**BEFORE THE NORTH CAROLINA UTILITIES COMMISSION
DOCKET NO. E-100, SUB 147**

In the Matter of:)	
2016 Biennial Integrated Resource Plans)	NCSEA’S
and Related 2016 REPS Compliance Plans)	[PUBLIC]
		COMMENTS

NCSEA’S COMMENTS

Figure 1²

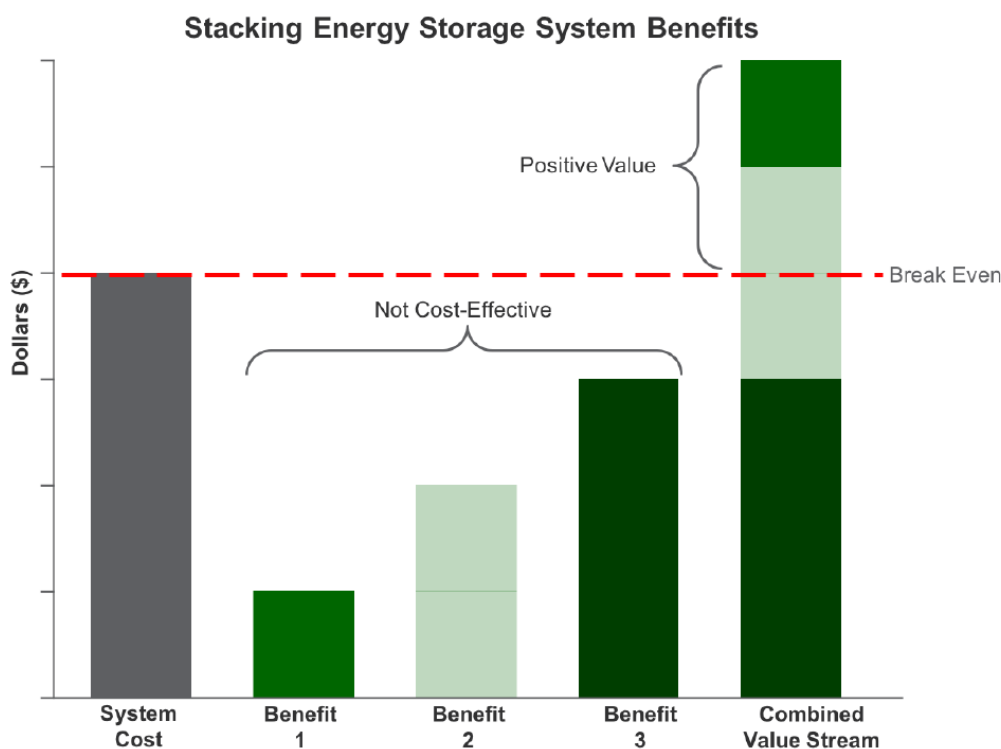
DEC and DEP's IRPs only analyze the generational value of energy storage and do not quantify the value of these additional benefits. As detailed in **Figure 1**, failing to value the full "stack" of energy storage benefits can (and in the case of the 2016 IRPs, it did) inadvertently exclude energy storage from the IRP and therefore all of its potential benefits to utilities and their customers.

Figure 2⁷

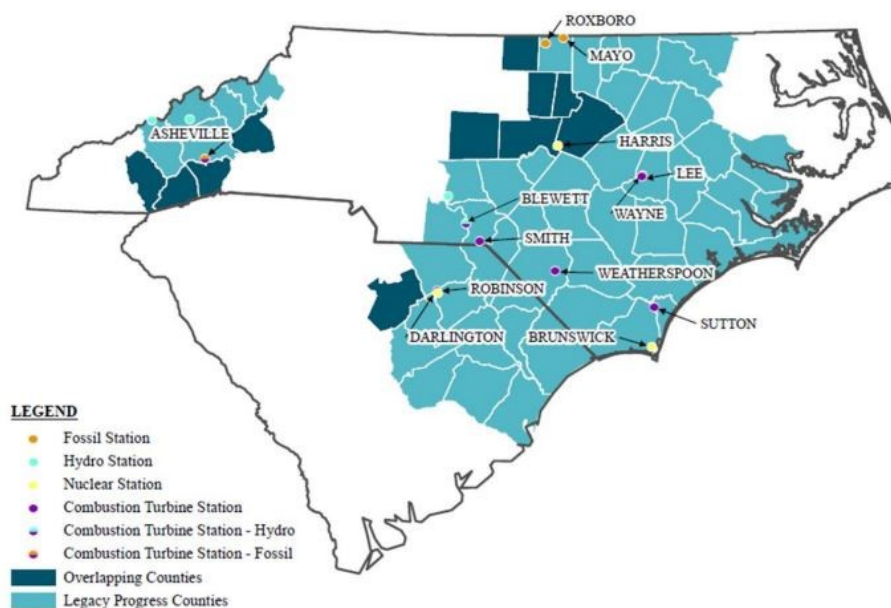
In addition to differing load forecasts, the DEP-East and DEP-West are two distinct balancing authority areas that have different, independent generating facilities and lack sufficient transmission capacity to allow them to operate as a single entity. As shown in **Figure 2**, the two service territories are geographically isolated and, as set forth below, there are several reasons why the geographic separation of the two service territories should dictate that they be planned differently.
